Index 641-010 Concrete Poles

COMMENTARY

SMO has proposed to remove Class V Special Concrete as an option from the Standard Specifications and therefore the Standard Plans must be updated.

Districts have requested an often used 16 ft pole configuration to be added.

SERVICE POLE TYPE P-IID (16 Ft.)

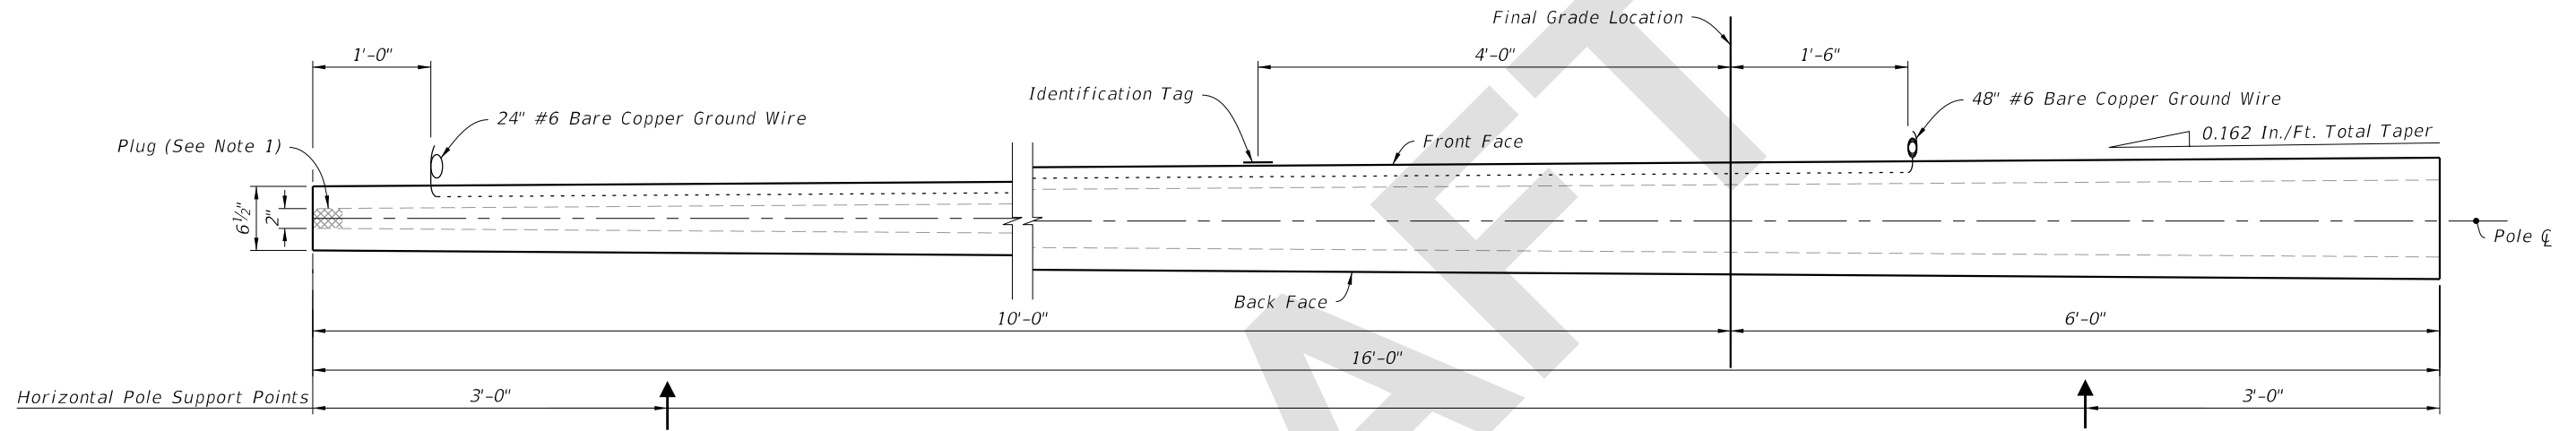
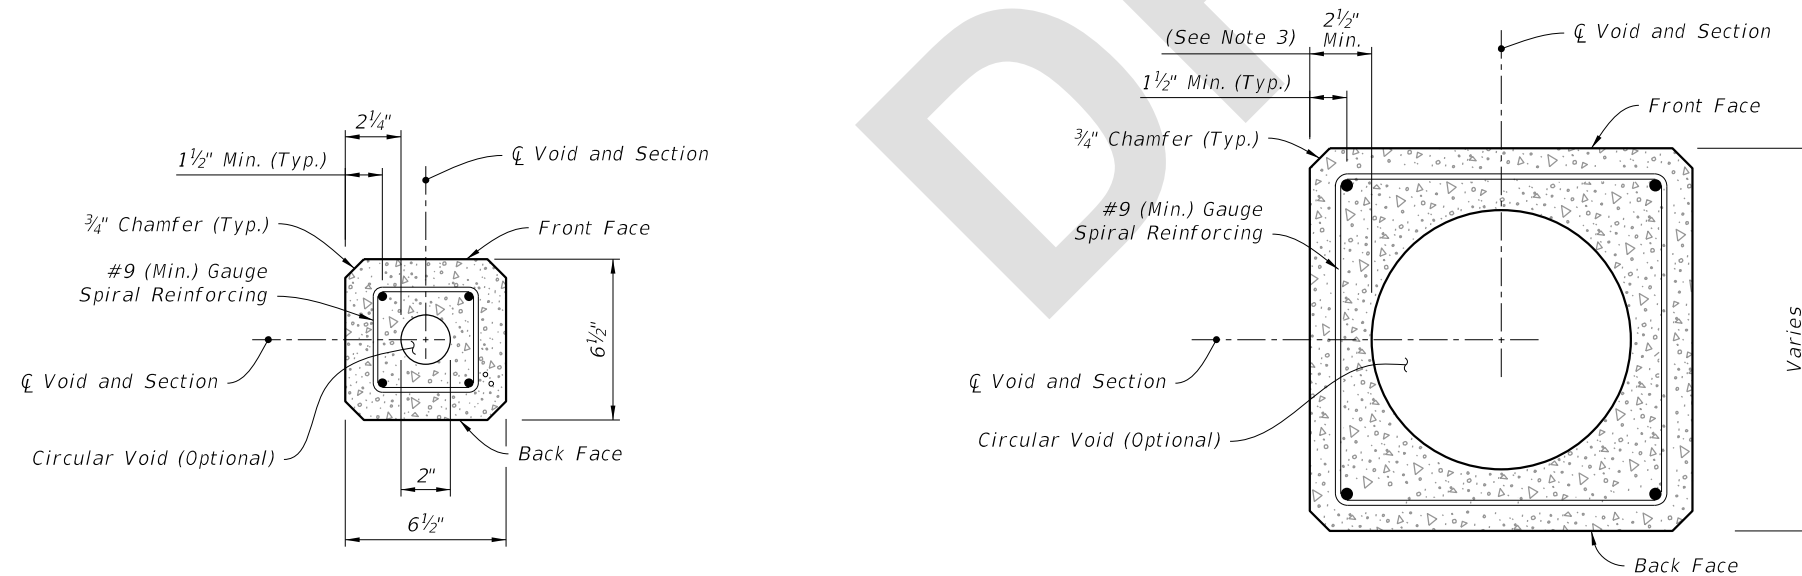
COMMENT: Comments for Sheet 5 of 11 are as follows:

1. In the pole elevation view, there is a label “Plug (See Note **3**)”. Please verify. It appears that this label should be “Plug (See Note **1**)”.

2. In Section B-B, there is a label “(See Note **5**)”. Please verify. It appears that this label should be “(See Note **3**)”.
3. Label at the bottom right corner of the sheet. To be consistent with other sheets, please consider including a space between “16” and “Ft.”. Instead of “16Ft.”, “16 Ft.”.

1. Agree. Note reference was in error.
CHANGE MADE TO INDEX: Corrected note reference.
2. Agree. Note reference was in error.
CHANGE MADE TO INDEX: Corrected note reference.
3. Agree.
CHANGE MADE TO INDEX: Added space.
4. Per the Origination Form, this 16-foot pole is included for use with project-specific service point designs that are already currently in use in the District. The deadline for requesting revisions to an index in the 2023-24 Standard Plans has passed, and there were no revisions proposed to Index 639-001 for this cycle. If there are specific
